Report Type: CC Access Report
Reference Number: 20074 C
Client: Barbara Tarnawski Architects
Site Address: Werrington County Child Care Centre
73 Henry Lawson Avenue
Werrington County NSW

ACCESS REPORT

This Access Compliance Report is to accompany a Construction Certificate Application for the development proposed at Werrington County Child Centre, 73 Henry Lawson Drive, Werrington County NSW.

This development proposes Additions and Alterations to an Existing building which operates as a child care centre. The development is within Penrith Council LGA.

[Image description: Plan of out door parking car space above shows the provision of Accessible parking spaces]

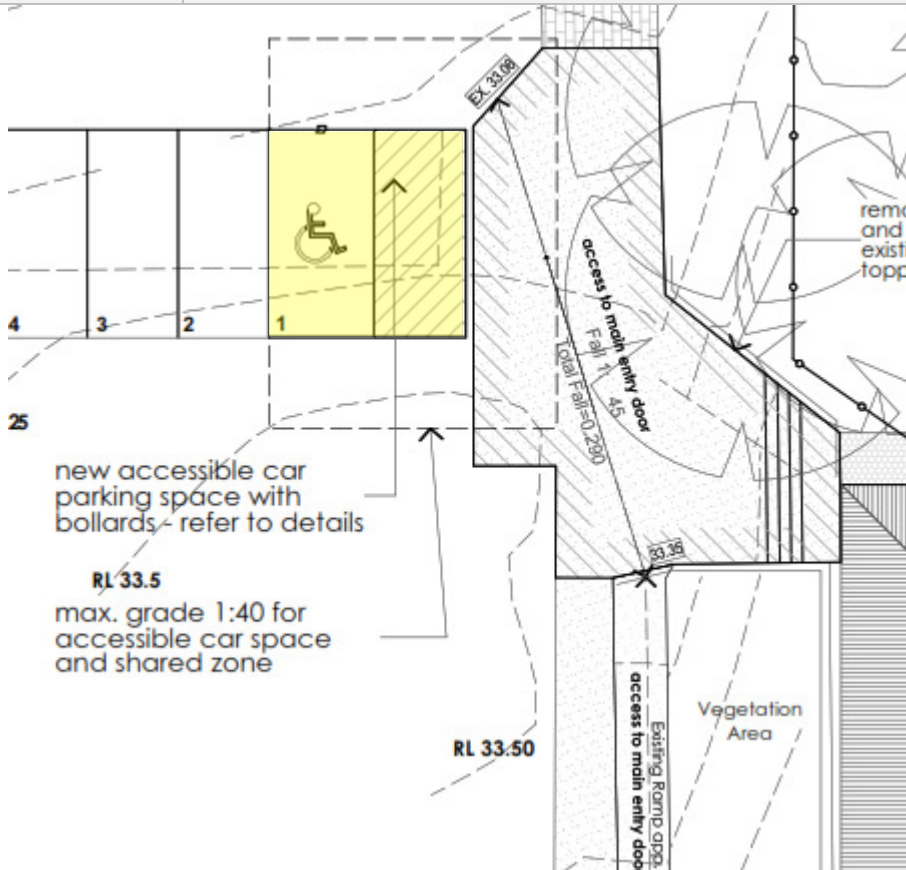
BCA Part D3.5 Accessible Carparking
Requirement	Class 9b School - 1 Accessible car parking space per 100 spaces provided Other assembly building - 1 Accessible car parking space per 50 spaces provided and then additional 1 Accessible car parking space per additional 100 spaces provided
Compliance Comments	Complies. Total number of Accessible parking spaces required / provided in the development = 1
